Submission for the Maules Creek Coal Mine Continuation Project - August 2025

Maules Creek Stock and Domestic Water Pipeline Association Inc (MCSDWPA)

Submission for the Maules Creek Coal Mine Continuation Project

1.8.2025

Figure 5-1 Hydrogeological conceptualisation B-B' (AGE, 2025)

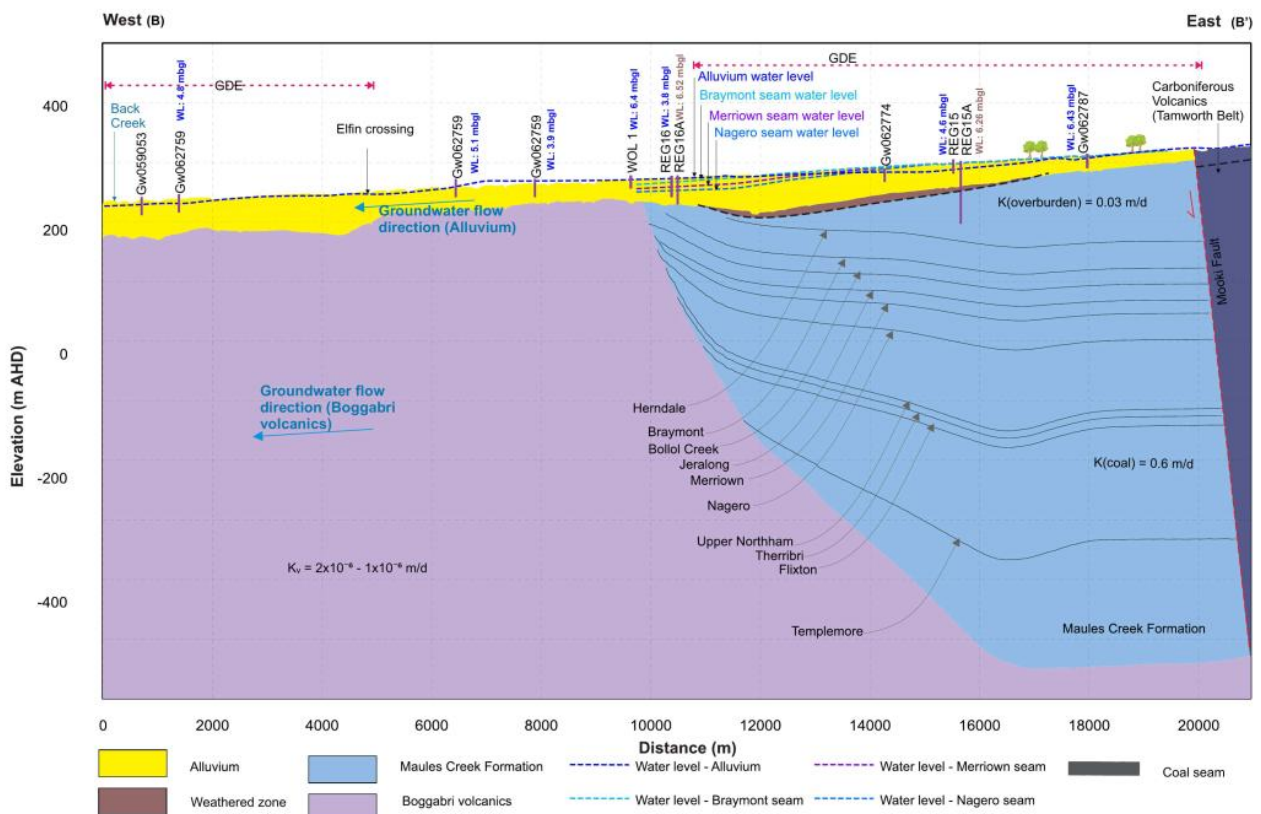
Hydrogeological conceptualisation B-B' (Figure 5-1) shows that there are limited groundwater bores penetrating the full thickness of the alluvium. Hence, there are limited bores that penetrate into the underlying Permian strata and Boggabri Volcanics. This reduces confidence in the interpreted stratigraphy and connectivity.

Figure 5-3 Hydrogeological conceptualisation D-D' (AGE, 2025)

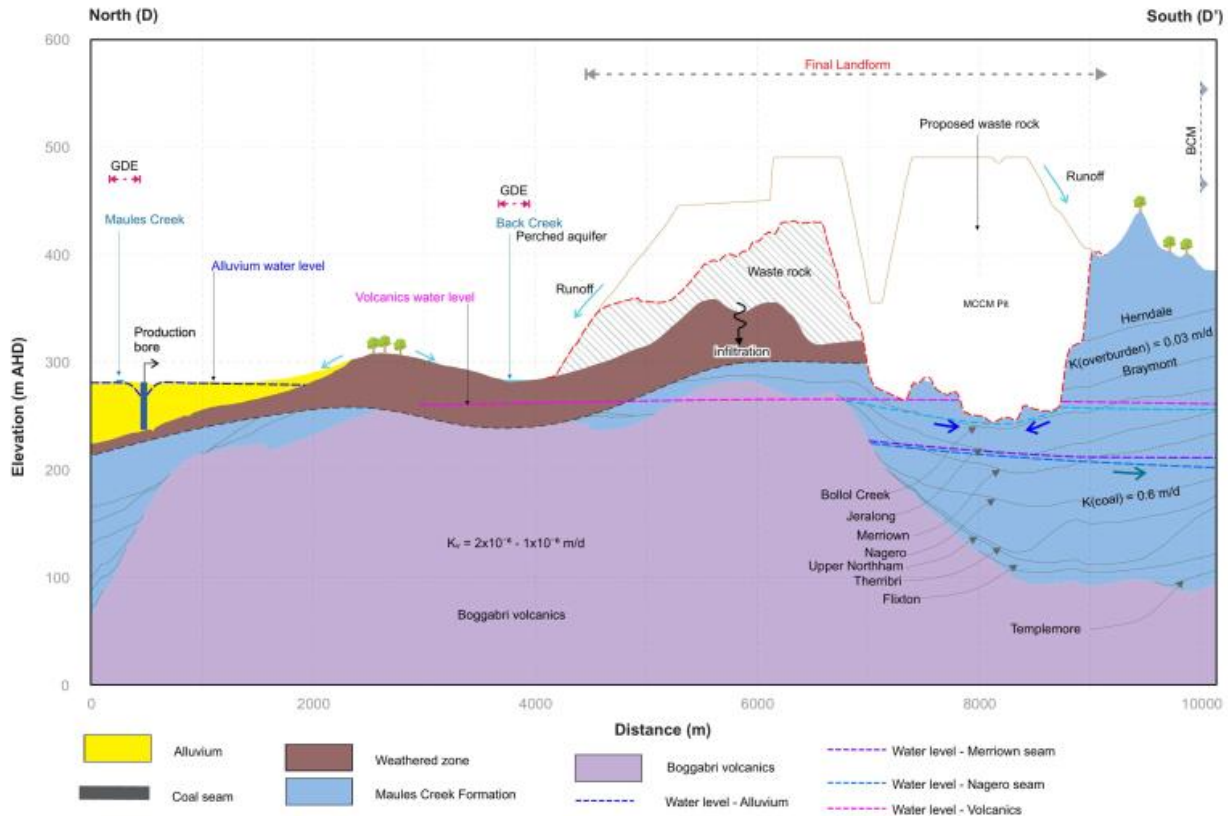
Hydrogeological conceptualisation D-D' is shown in Figure 5-3. The conceptual model does not represent any groundwater bores within the cross section. This limits the ability to validate the interpreted groundwater levels and geology.

The Boggabri Volcanic groundwater level appears disconnected from the weathered zone towards the alluvium but remains continuous towards the MCCM Pit. The alluvium exceeds 50 m in thickness (which is significantly different to the alluvium thickness that is shown in Figure 5.3 of AGE (2025)), and there is no separation depicted between the Narrabri Formation and the Gunnedah Formation, which is a critical component of the groundwater conceptualisation. The alluvial groundwater table is shown as being hydraulically disconnected from the Permian strata by the weathered zone. Further to this there is minimal information or data provided to support the thickness and extent of the weathered zone. Table 7.1 of AGE (2025) states that the weathered zone ranges between 1 m to 30 m thick, however hydrogeological conceptualisation D-D' shows the weathered zone to be at least 50 m or 60 m thick in some areas of the section.

Without verified groundwater level data across the described units, the hydrogeological conceptual model lacks the necessary evidence to support assumptions regarding flow directions, aquifer connectivity and hydraulic separation.

Figure 5-4 Hydrogeological conceptualisation E-E' (AGE, 2025)

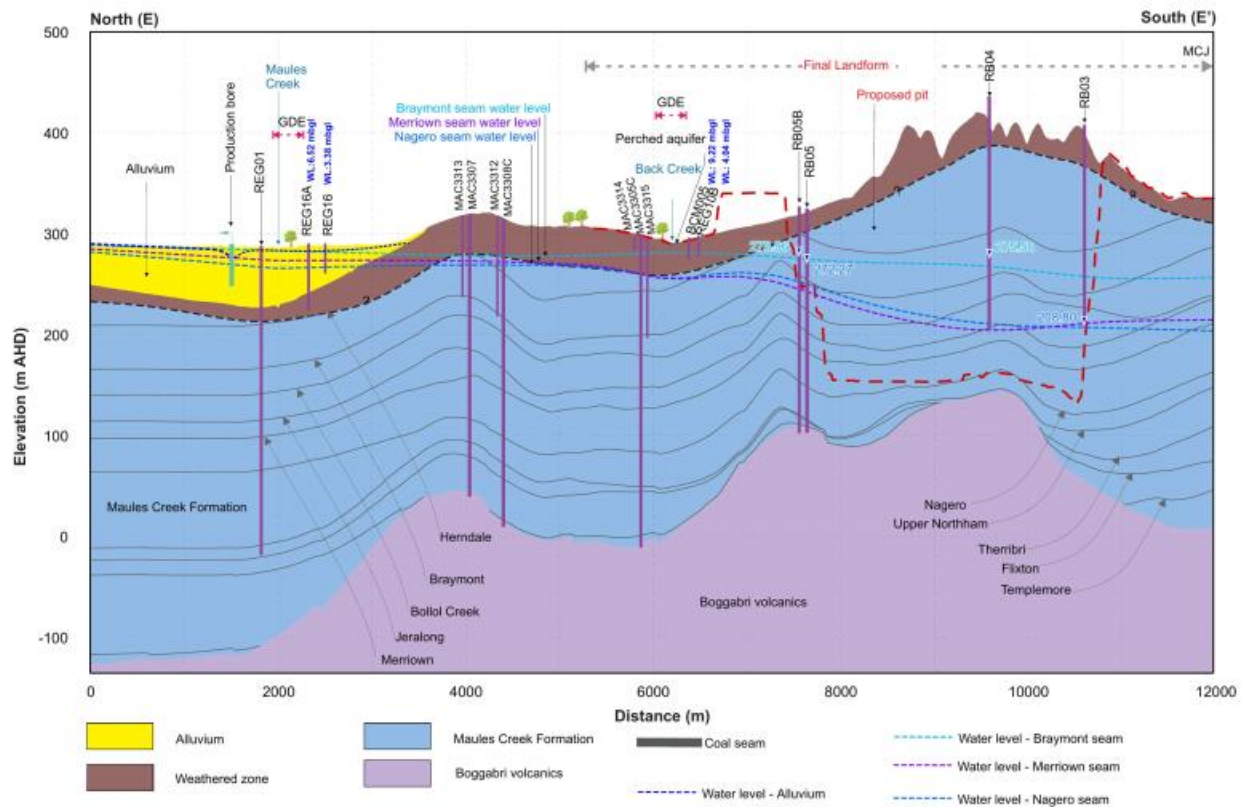
Hydrogeological conceptualisation E-E' shown in Figure 5-4 displays uncertainty in the weathered zone thickness south of REG16 (see use of question marks) and does not clearly define the connection between the alluvium and the sub cropping coal seams. The alluvium appears to exceed 50 m in thickness, and there is no distinction or separation shown between the Narrabri Formation and the Gunnedah Formation. The weathered zone is noticeably thicker near the alluvium, particularly in the northern part of the cross-section around Maules Creek. There is minimal data available to show the weathered zone as the main pathway for lateral groundwater flow from the alluvium to the coal seams.

The conceptualisation that the weathered zone represents the primary lateral groundwater flow pathway between the alluvium and the underlying coal seams is not substantiated by data. The conceptual model does not present dedicated monitoring bores, hydraulic head measurements, or permeability data within the weathered zone to verify lateral connectivity. Further information or data is required for the weathered zone beneath the alluvium, and between the alluvium and the MCCM to confirm pathways for groundwater flow between the alluvium and the coal seams.

Figure 5-5 Top of Boggabri volcanics (AGE 2021 and 2025)

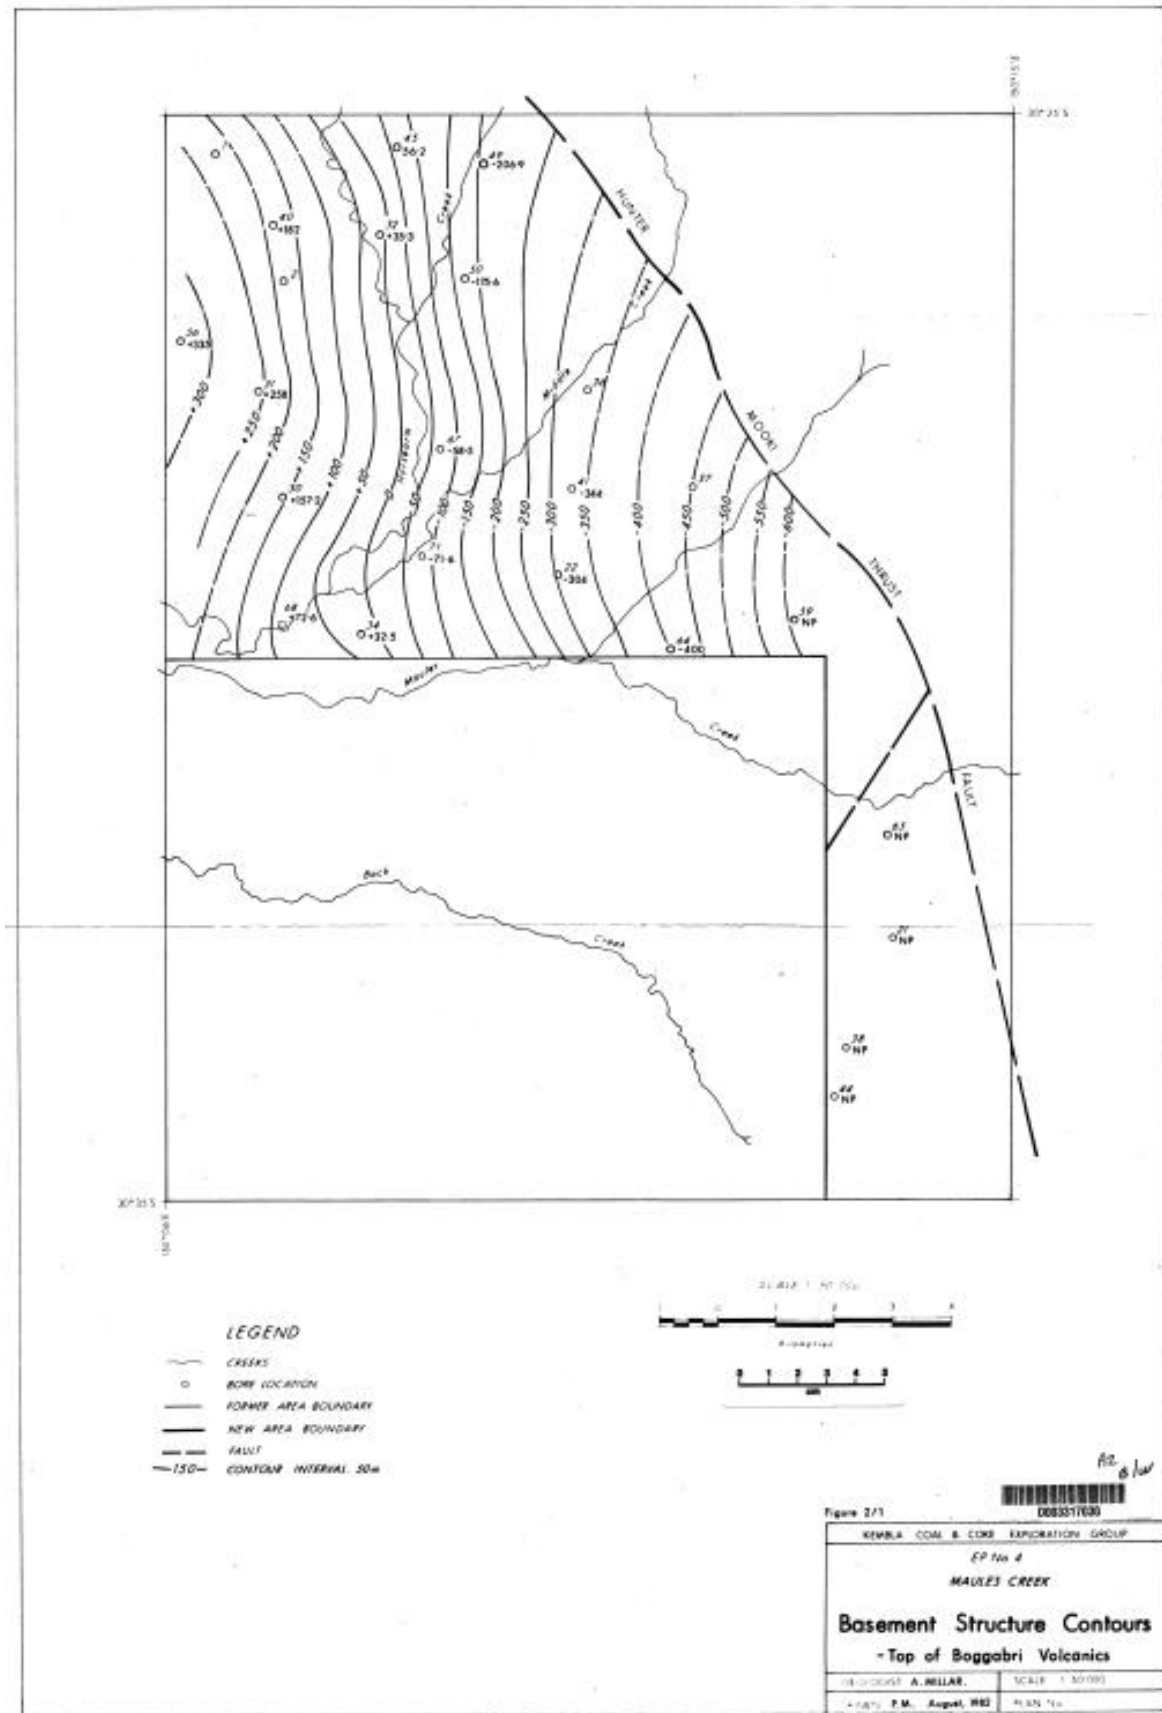
A key input to the groundwater model is the representation of the Boggabri Volcanics basement surface. The Boggabri Volcanics basement surface which is represented in the AGE 2025 report is significantly different to that presented in previous reporting (AGE, 2011 and AGE, 2021). Figure 5-5 shows the comparison between the Boggabri Volcanics basement surface presented in AGE (2021) versus AGE (2025).

Approaching Maules Creek, AGE (2021) shows the top of the Boggabri Volcanics rising toward the west, with elevations approaching 250 mAHD, and dipping westward to below -150 mAHD, forming a clear east west gradient (Figure 5-5). AGE (2025) confirms the presence of this east west gradient and westerly structural high but introduces a steeper elevation gradient from east to west. This difference indicates that an update or reinterpretation of the Boggabri Volcanics surface must have been carried out between 2021 and 2025. However, there is no mention of additional drilling that has been completed between 2021 and 2025 in this area to warrant the reinterpretation of the Boggabri Volcanics structure contours. The source dataset used to generate the Boggabri Volcanics surface is not specified and further clarification is needed to understand why this was carried out and the implications this has on the model calibration and predictions.

Figure 5-6 Top of Boggabri Volcanics (Pacific Coal, 1982)

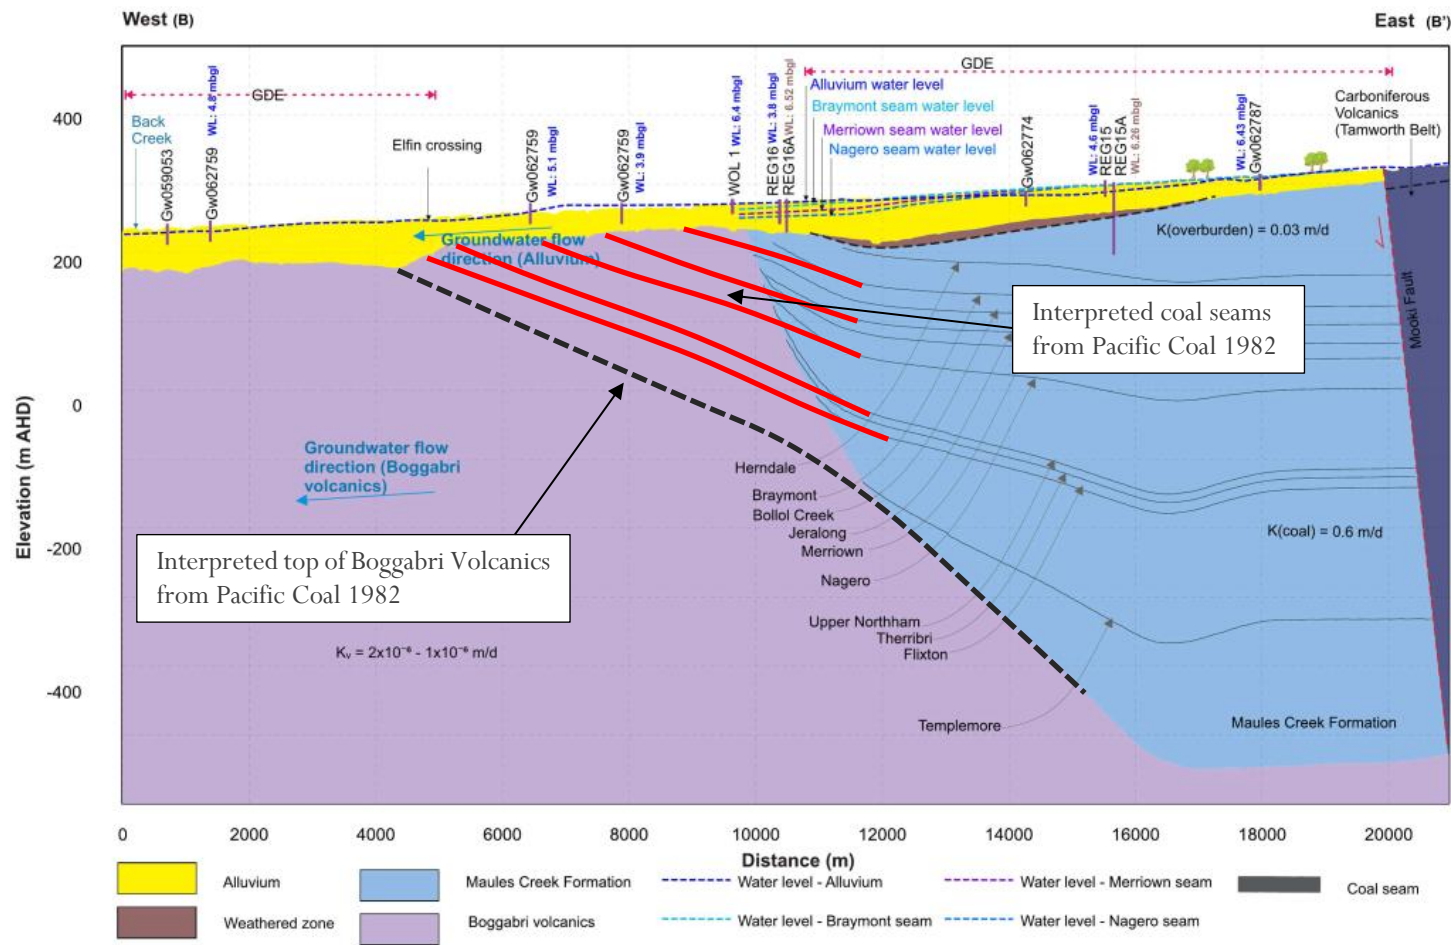
An additional map showing the top of the Boggabri Volcanics is shown in Figure 5-6. This figure is contained within a coal exploration report (Pacific Coal, 1982) which was downloaded from NSW DIGs. The map also shows the location of numerous coal exploration drill holes that were used to interpret the top of the Boggabri Volcanics.

Figure 6 - 1

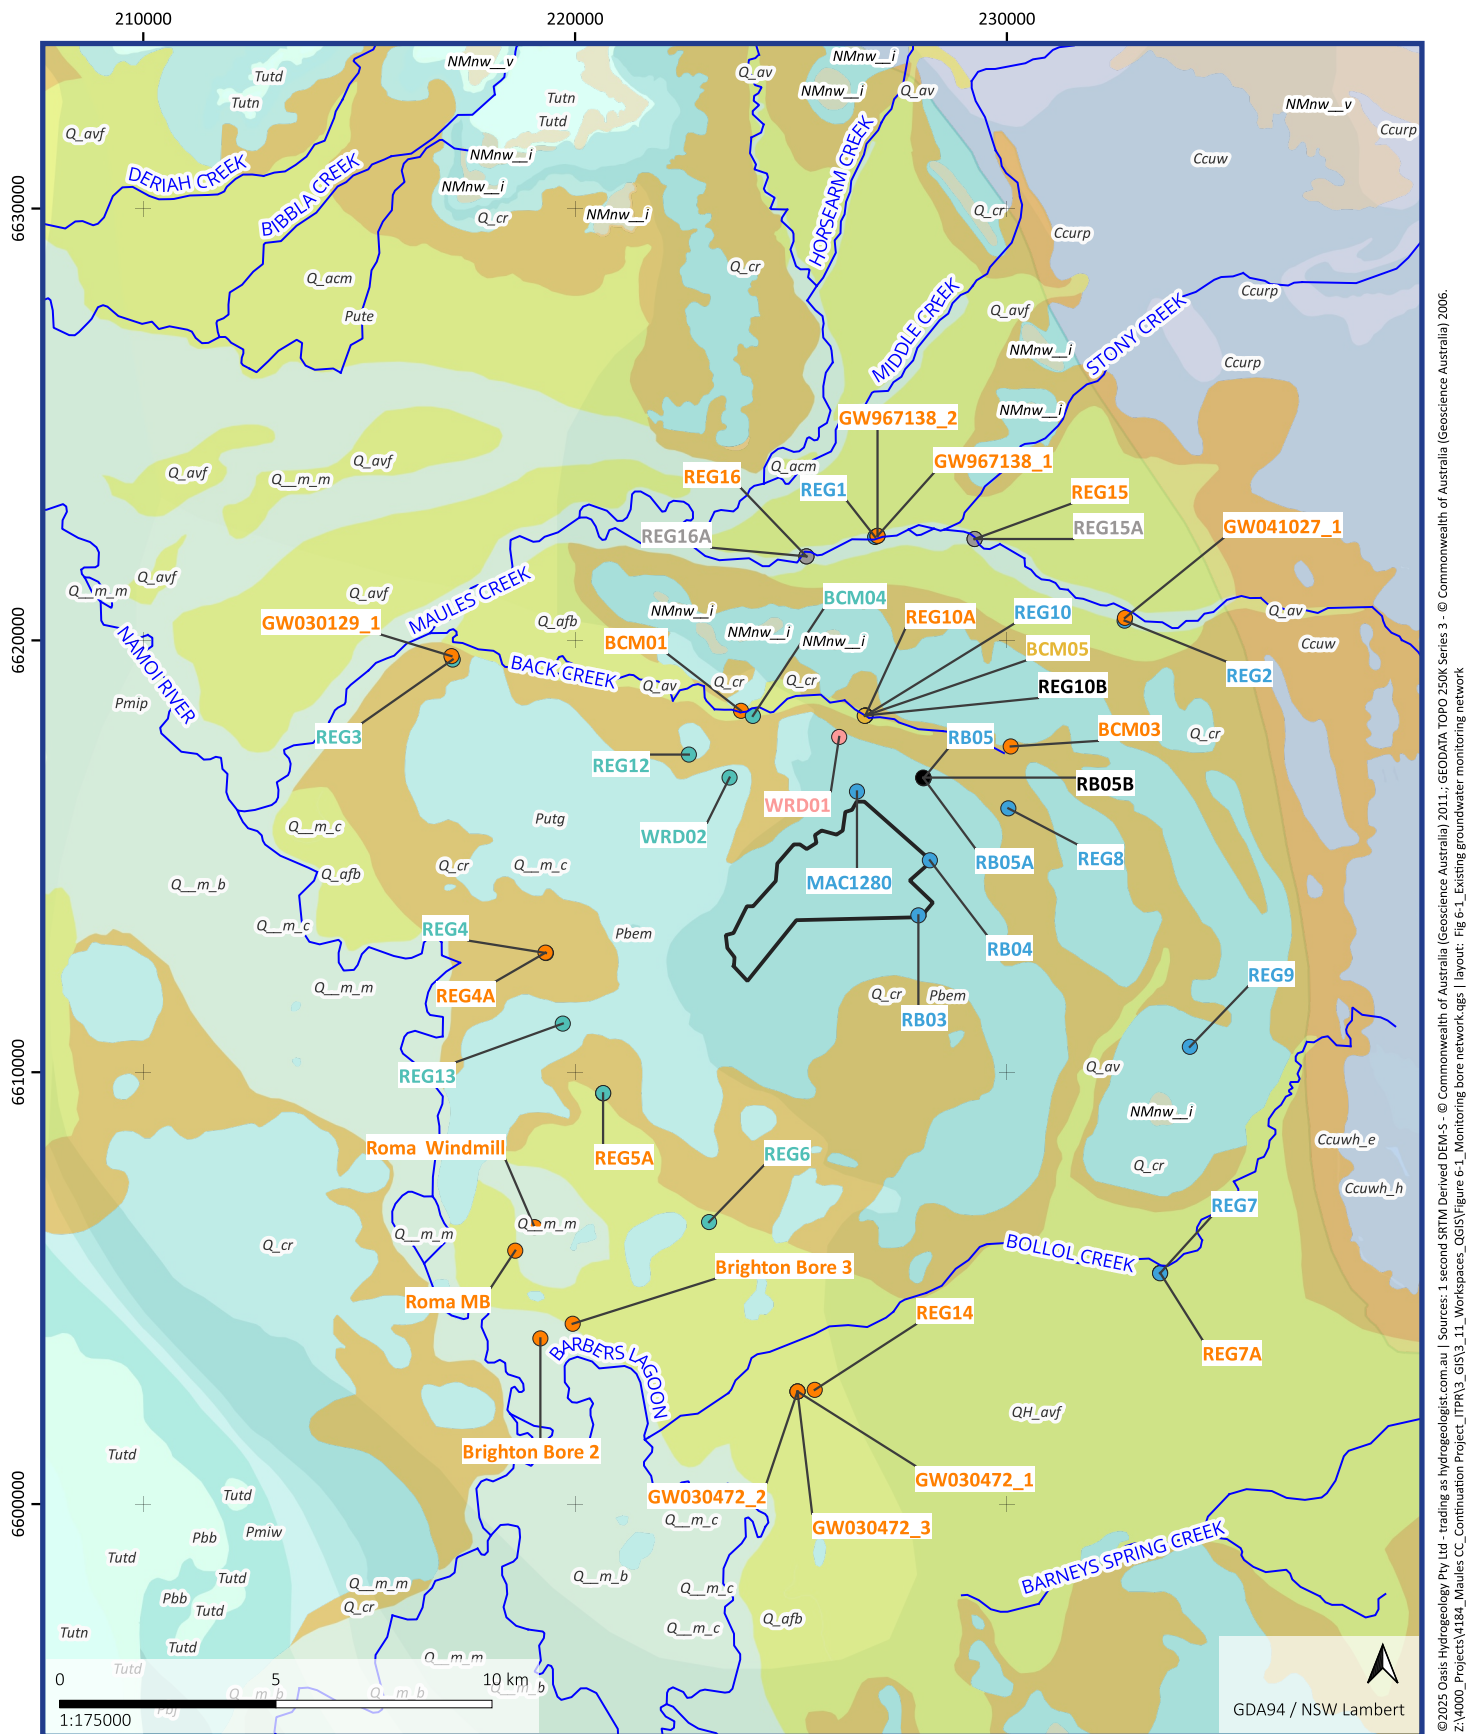
The GWMP lacks a figure that shows the current consolidated groundwater monitoring network. A table of the 45 active monitoring bores are listed in Table 6-1 and Figure 6-1 shows the existing groundwater monitoring network. Consisting of monitoring bores 21 alluvium, 1 weathered overburden, 8 volcanics, 15 Permian strata (including coal seams).
